A RESOLUTION AUTHORIZING THE VILLAGE ADMINISTRATOR OR MAYOR
TO APPROVE A CHANGE ORDER FOR THE SCHOOL HOUSE ROCK PROJECT

PR 001
Storm Sewer Add

JOB: Village of Covington
PROJECT: Schoolhouse Park Pavilion

JOB NAME: Covington Schoolhouse
Park Crosswalk Catch Basin

**PROPOSED
CROSS WALK CATCH BASIN**

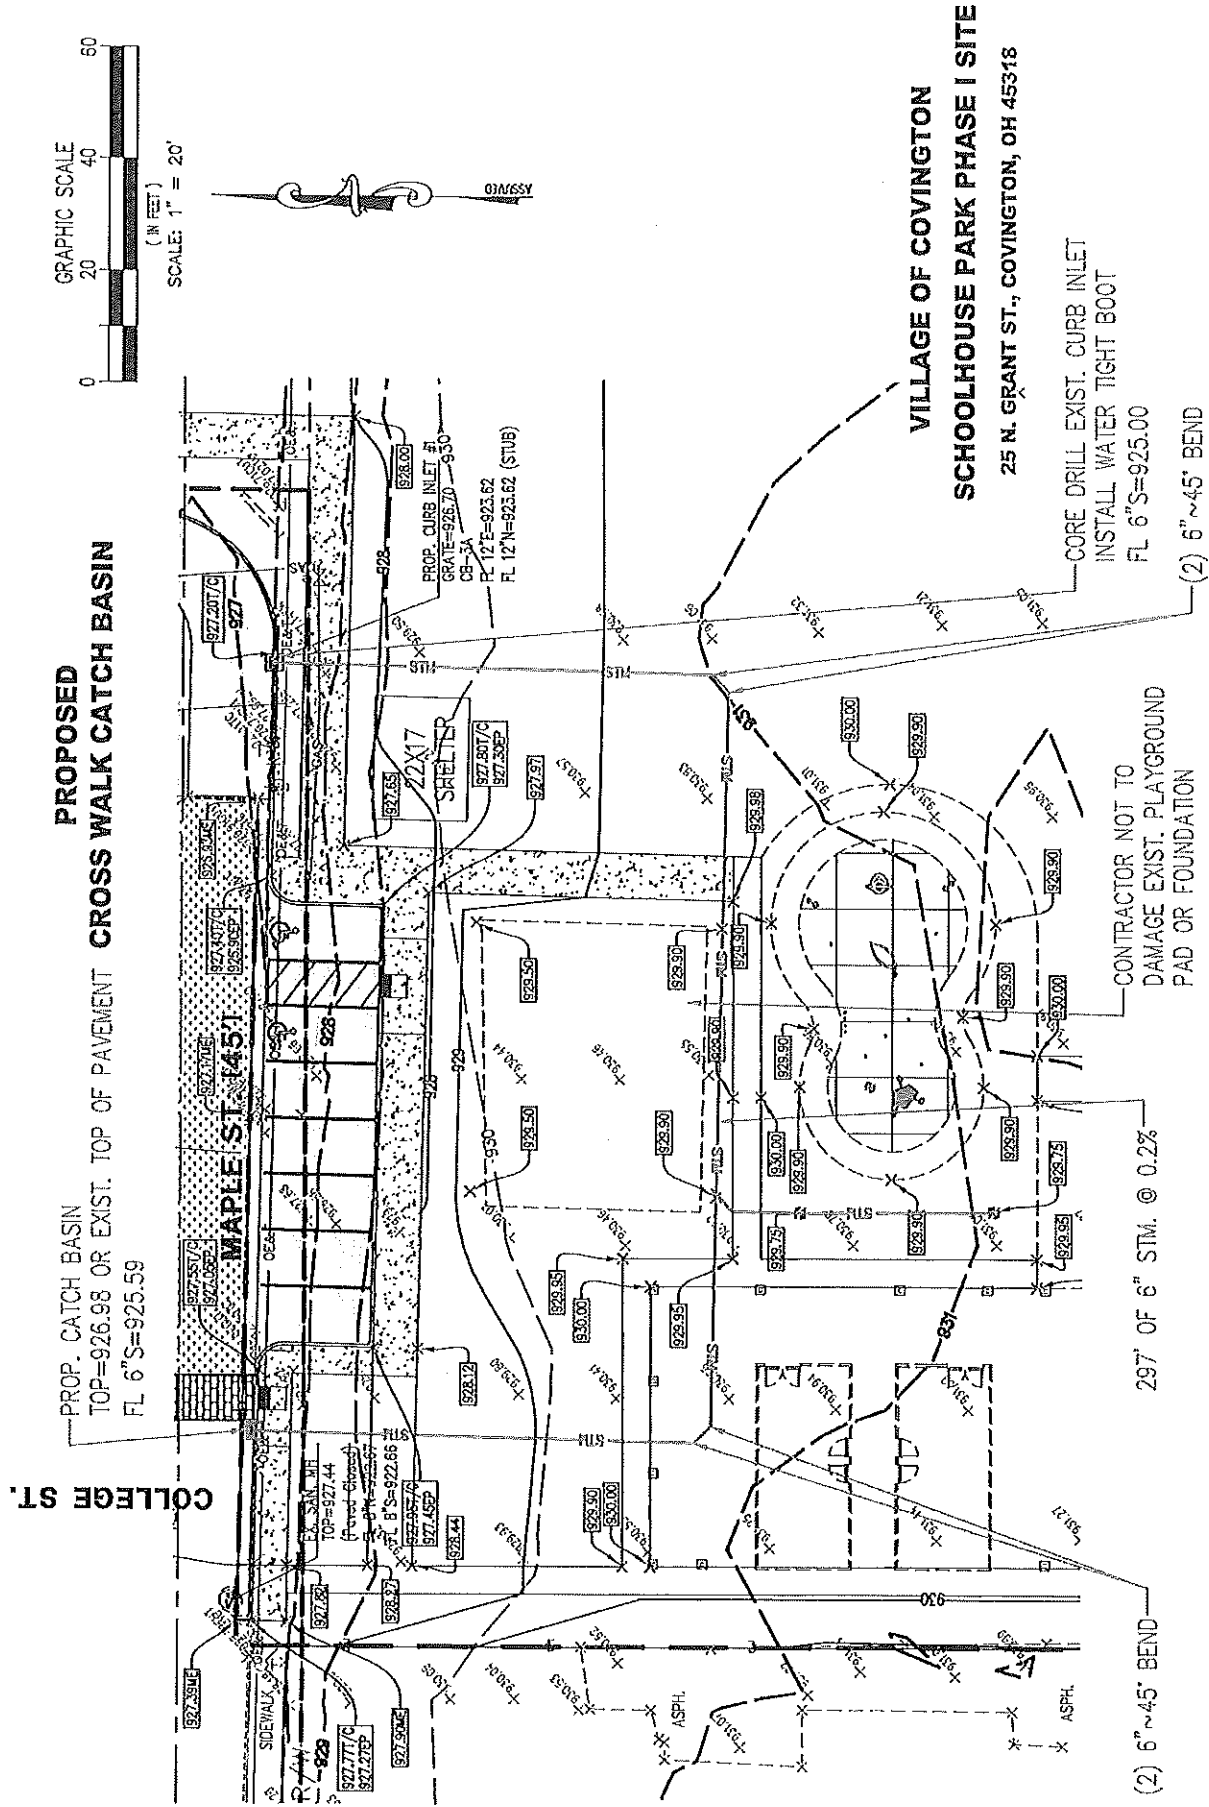
1. Material, labor, and equipment to add a new catch basin on Maple Street and connect to existing catch basin as per the attached drawings. The connection of the (2) existing drain basins at the Splash Pad are included.

1. Core into existing catch basin and install 6" Kor-n-seal Boot.
2. Furnish and install 350' of 6" SDR 35 pipe.
3. Furnish and install Curb Inlet Type 3A. Curb and asphalt repair by others.
4. Connect new storm sewer to 2 existing drain basins.
5. Bed and backfill pipe as required.

PROP. CATCH BASIN
TOP=926.98 OR EXIST. TOP OF PAVEMENT
FL 6" S=925.59

CORE DRILL EXIST. CURB INLET
INSTALL WATER TIGHT BOOT
FL 6" S=925.00

CONTRACTOR NOT TO
DAMAGE EXIST. PLAYGROUND
PAD OR FOUNDATION

297' OF 6" STM. @ 0.2%
